# PERMIT CHANGE TRACKING FORM

DATE RECEIVED	4/13/95	PERMIT NUMBER	ACT 1015/019
Title of Proposal:	Sewage System	PERMIT CHANGE #	95C
Description:	Connection to Trail Mtn. System & Cottonwood Mine	PERMITTEE	Pacificorp
		MINE NAME	Cottonwood Mine

**RE: TRAIL MOUNTAIN MINE SEWAGE SYSTEM MODIFICATION, PACIFICORP,  
COTTONWOOD MINE, ACT/015/019, EMERY COUNTY.**

**RE: TRAIL MOUNTAIN MINE SEWAGE SYSTEM MODIFICATION, PACIFICORP,  
COTTONWOOD MINE, ACT/015/019, EMERY COUNTY.**

**FIGURE 3**

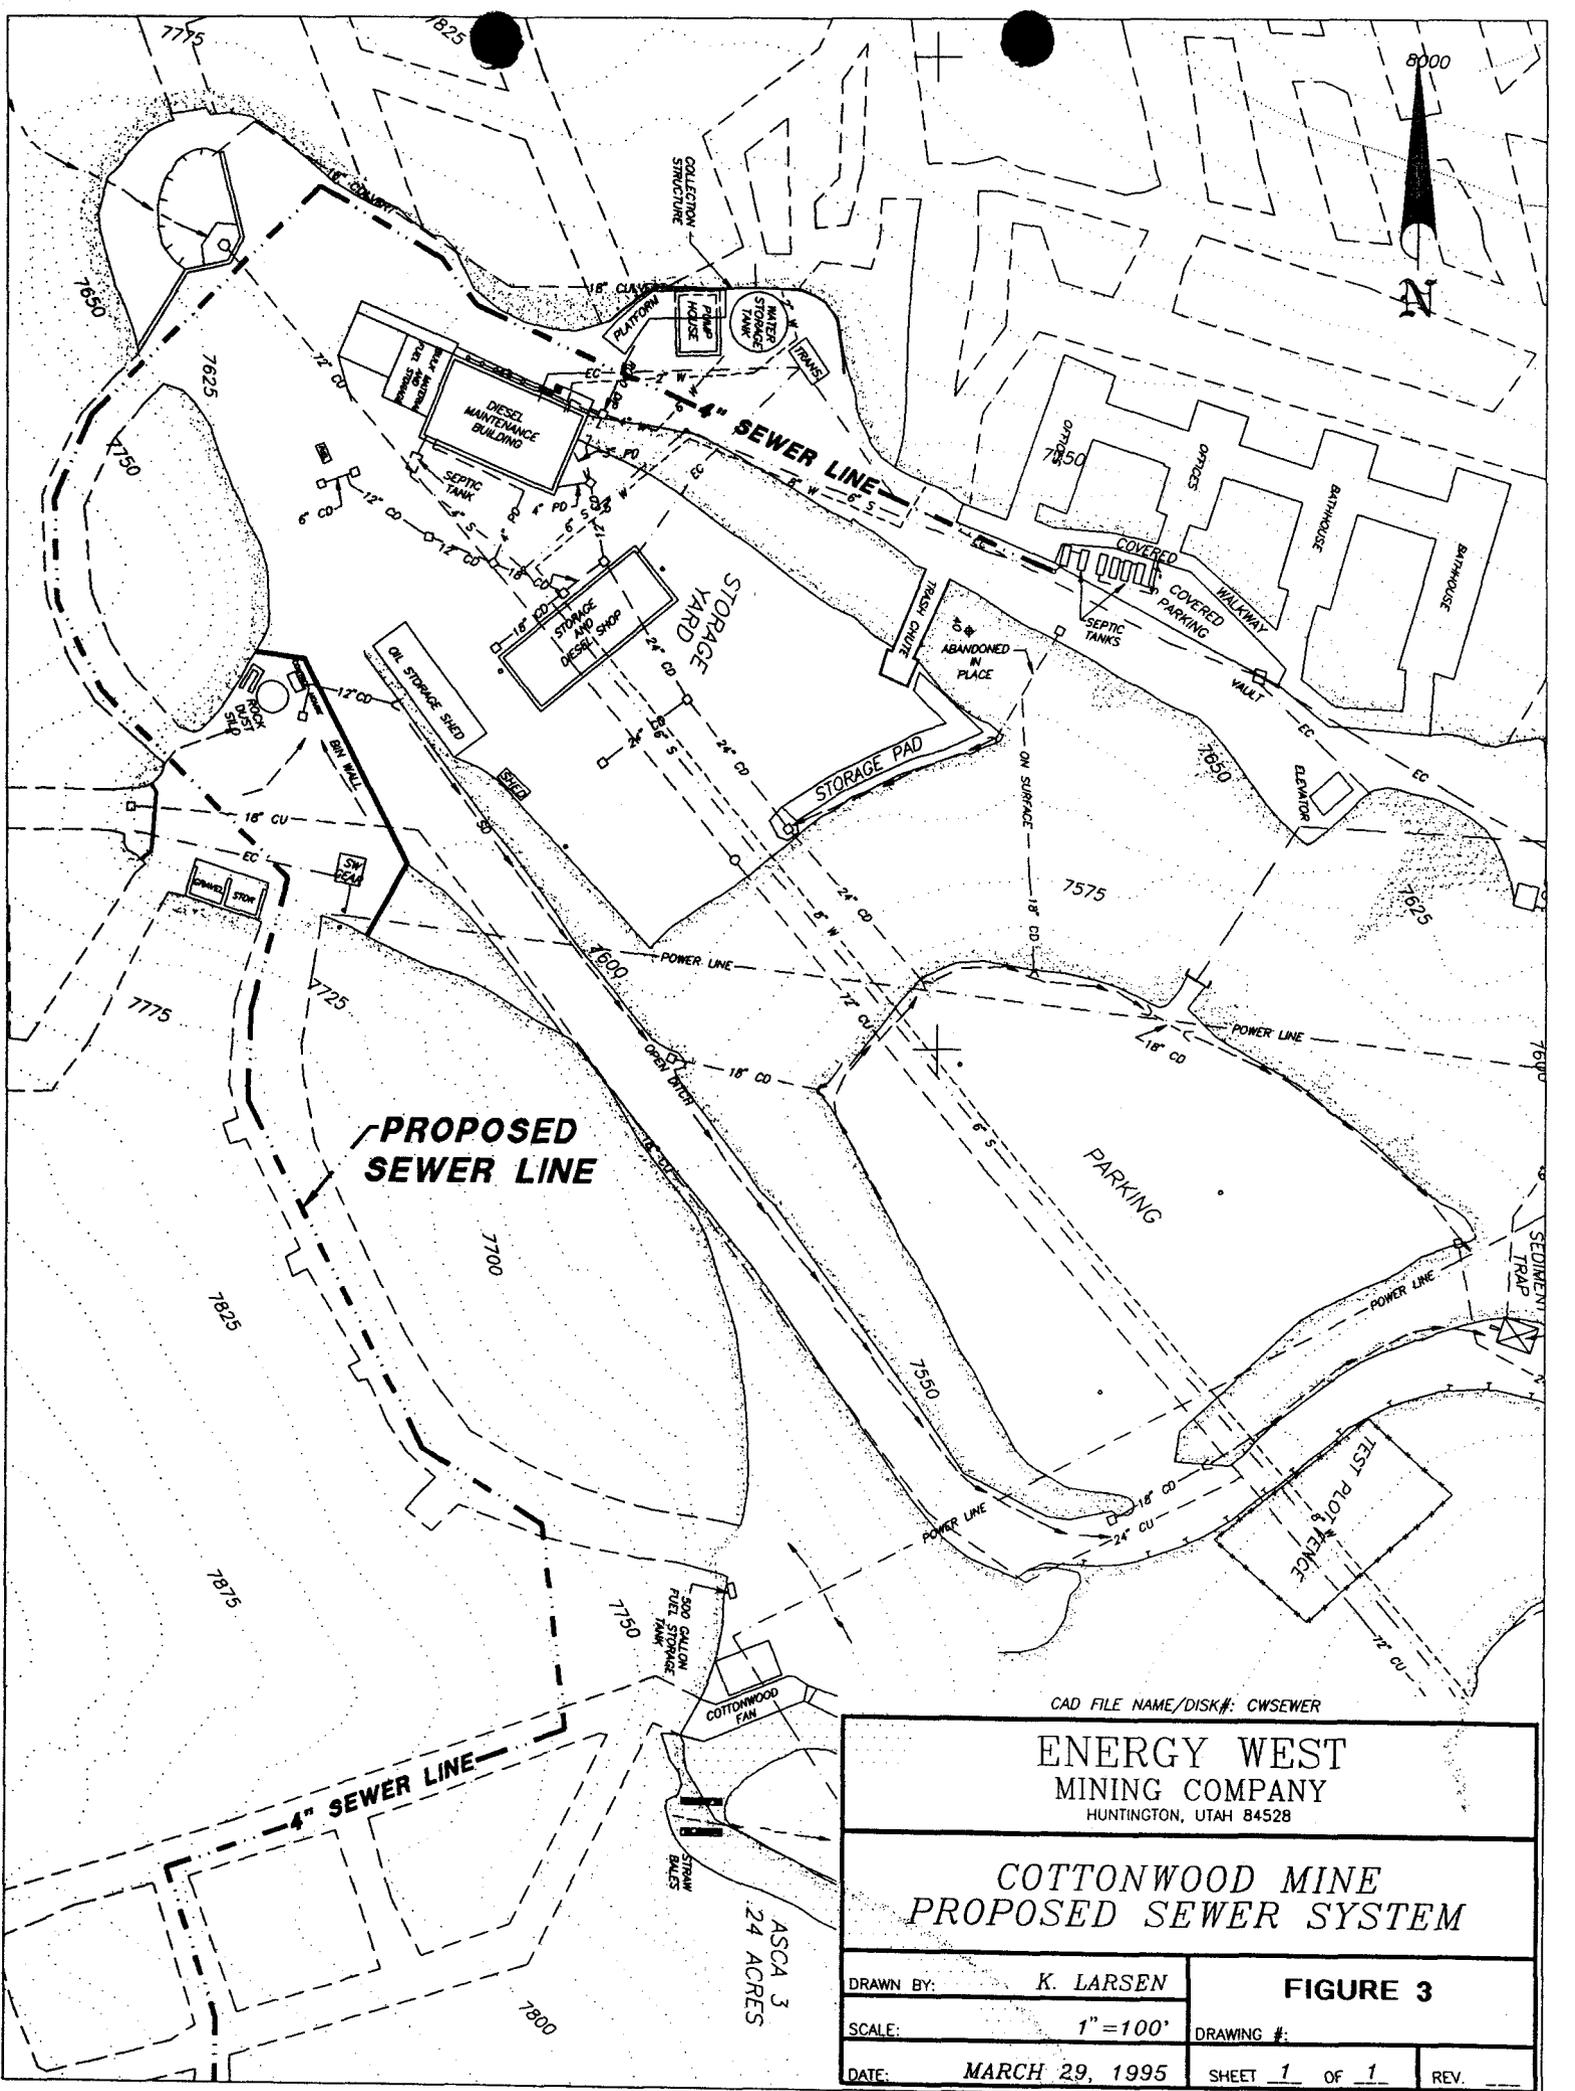
To help with the review of this amendment, Figures 1 through 3 have been included herein. Figures 1 and 3 depict the line location at the Cottonwood Canyon area and the Cottonwood Mine. Figure 2 is a typical cross-section of the buried line.
